Report No. EGG-EA-5304

Adequacy of Station Electric Distribution System Voltages, La Crosse Boiling Water Reactor, Docket No. 50-409, TAC No. 12763

December 1980

LA CROSSE BOILING WATER REACTOR

LA CROSSE
 UNIT ONE LINE DIAGRAM
 FIGURE 1

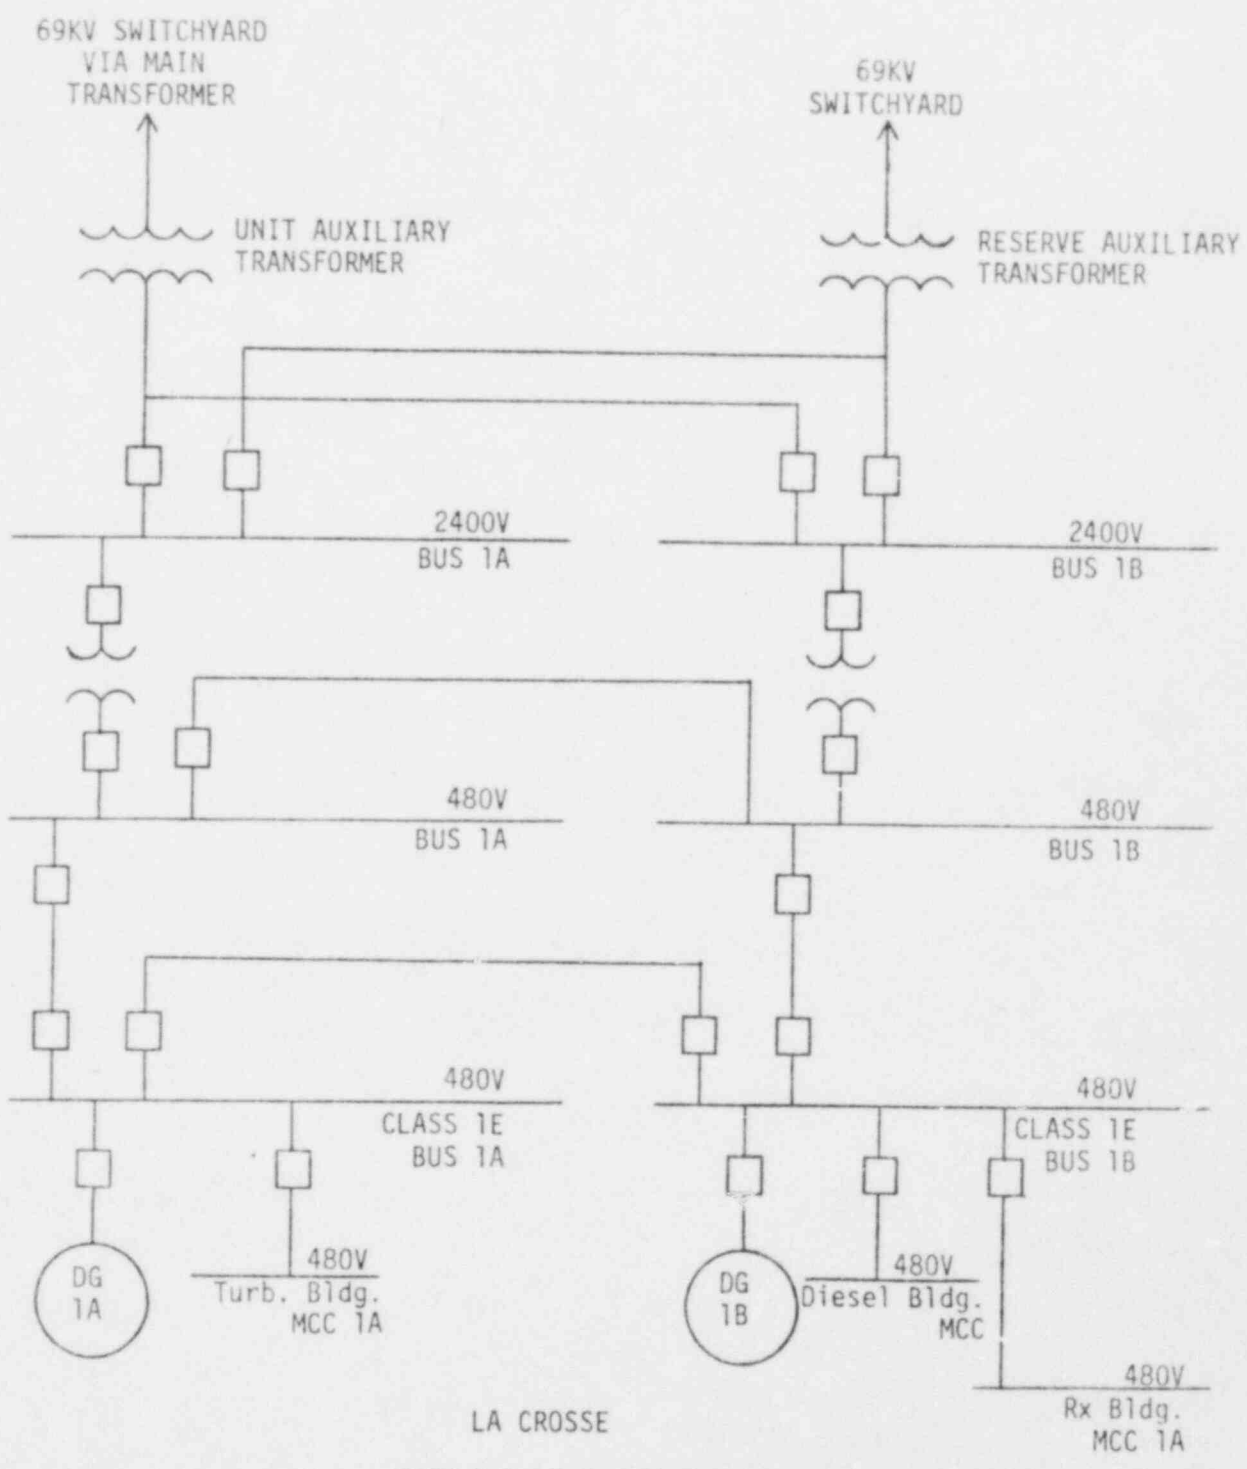
Figure 1 of this report is a simplified sketch of the unit one-line diagram taken from the Sargent & Lundy report.³ It shows that 480V class 1E buses 1A and 1B are supplied power by 480V auxiliary buses 1A and 1B, respectively, which, in turn, are powered by 2400V buses 1A and 1B by separate transformers.

There is only one reserve auxiliary transformer to supply offsite power for all buses. The unit auxiliary transformer cannot be used as a reserve source. There is automatic transfer from the unit auxiliary transformer to the reserve auxiliary transformer in the event of a unit trip.

Undervoltage relaying is provided on class 1E buses 1A and 1B³ to separate the bus from offsite power should the voltage be degraded or lost.

DPC has not analyzed the La Crosse connections to the offsite power grid. However, the DPC submittals show only one reserve auxiliary transformer with no other available connection to the offsite grid. This does not meet the GDC 17 requirement that two physically-independent circuits be available or that no potential exists for simultaneous or consequential loss of both circuits.
